**MITTEILUNG**  
**Gurtzeuge**

Bezug: Mitteilung über eine Technikinformation der FAI von 1/2009 **W.N. 22** ,  
Loop-Bruch am Riser Rigging Innovation

<b>Technical &amp; Safety Information Notice No.</b>	01/2009 <span style="float: right;">W.N. 22</span>
<b>Date of Issue</b>	28 January 2009
<b>Subject Matter and Applicability</b>	<p>Following a riser failure on a PA Talon, the Australian Parachute Federation's Director Rigging, Jo Chitty, issued the following notice. This notice is of mandatory status for APF members, and it is being distributed by the Technical &amp; Safety Committee of IPC to alert skydivers worldwide to the issues concerned.</p> <hr/> <p style="text-align: center;"><b>IMPORTANT ANNOUNCEMENT FROM THE DIRECTOR OF RIGGING, AUSTRALIAN PARACHUTE FEDERATION. MANDATORY INSPECTION OF ALL 3-RINGS PRIOR TO NEXT USE</b></p> <p><b>RISER FAILURE</b> On Sunday 18 January 2009, a <b>PA Talon</b> riser failed on opening. It was the left riser with RSL fitted. The reserve was deployed into the trailing main by the RSL resulting in a main reserve entanglement. Fortunately and with luck the jumper managed to attain sufficient reserve inflation to survive the landing with broken

**Typical view of locking loop length**

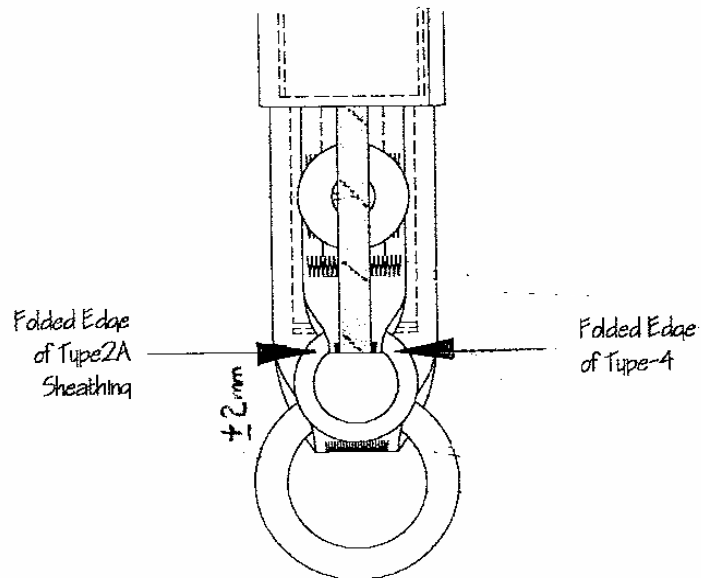
On all solo rigs and all types of riser style, one inch type 17 mini rings, type 8 mini rings and standard type 8 with the larger rings, the length of the locking loop should be level (+/- 2mm) with the end of the fold of the webbing that retains the small ring when the riser is laid flat with some tension applied to the small ring.

It is normal for new type 17 mini risers to be tight to interlock the rings, this is because they become more pliable with use, but the locking loop must still allow the housing some play and not pull the small ring against the riser, see side view on service bulletin.

**MANDATORY INSPECTION** in accordance with APF Service Bulletin [APF010801-B](#)\* Issued 23<sup>rd</sup> January 2009 of all 3-ring riser assemblies before the next jump. Inspection to be noted on reserve packing card and marked on inside of front riser with APF010801-B using a fine tip paint pen so it will be visible even if the risers are black.
